# UNITED STATES PATENT AND TRADEMARK OFFICE

10/596,706

<b>Office Action Summary</b>	<b>Application No.</b> 10/596,706	<b>Applicant(s)</b> MEINERS ET AL.	
	<b>Examiner</b> Tony G. Soohoo	<b>Art Unit</b> 1774

## **DETAILED ACTION**

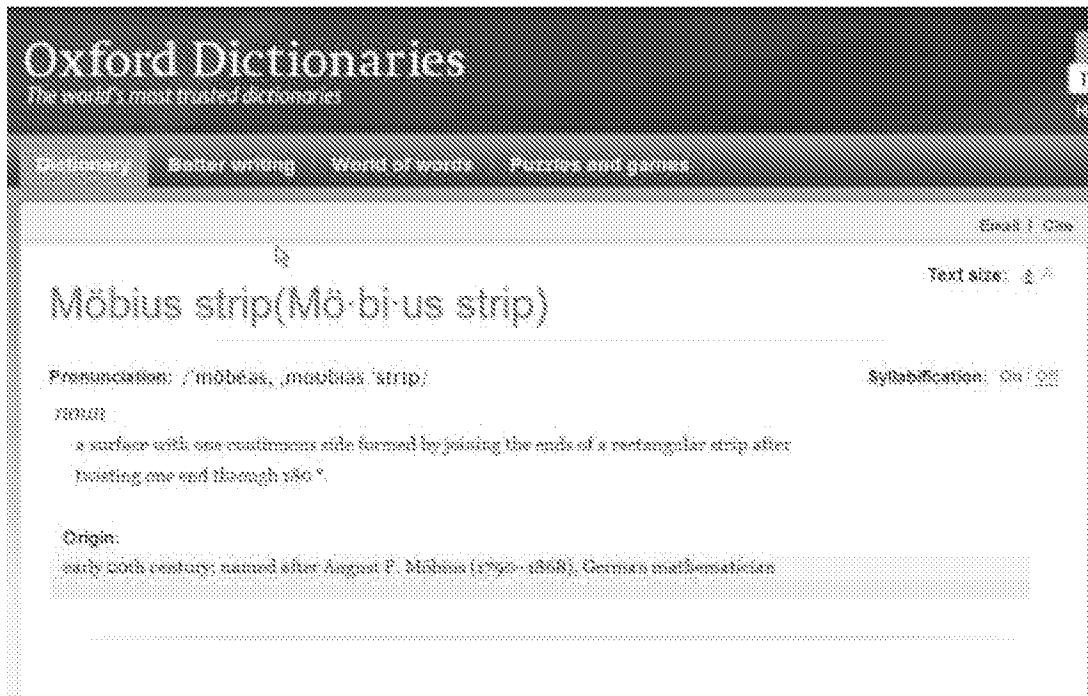
5. The examiner has attempted to the use a dictionary meaning of "mobius". However a dictionary search does not clearly define or enable the meaning of "mobius" in a clear context of this application. "Mobius" is the surname of a 20th century

mathematician. A search of the dictionary does not define "mobius" solely, but only yields the phrase "mobius strip".

- 7.
8. No where in the drawings show the structural element which exhibits a single edged, one continuous sided surface of a mobius strip.
9. Applicant points to the paragraphs [0052], [0053], [0054], [0064], [0065] and [0060] of the specification in the published US pregrant publication 2007/0177458 as support to the claim language. However the vague contextual description in those
